**PLDV-000164-2022: Resubmittal Required**

Figure 4.4-2: Interior Parking Area

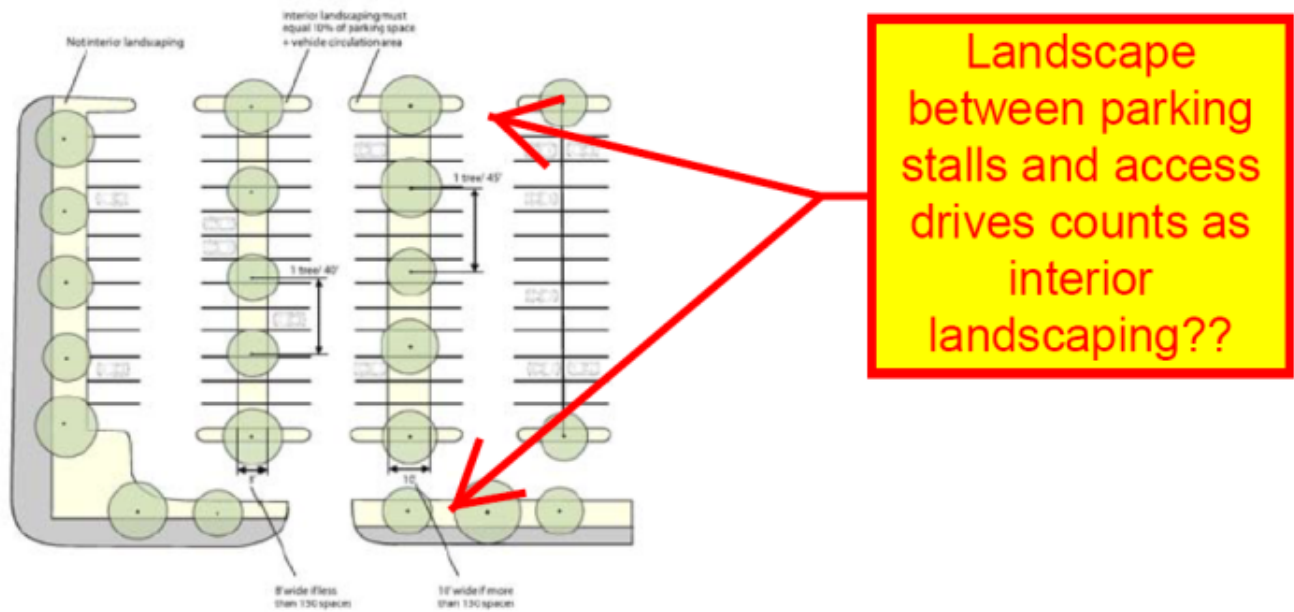
Regarding our discussion on interior landscaping, I thought the landscaping between the parking stalls and the access drives counts as "interior landscaping."
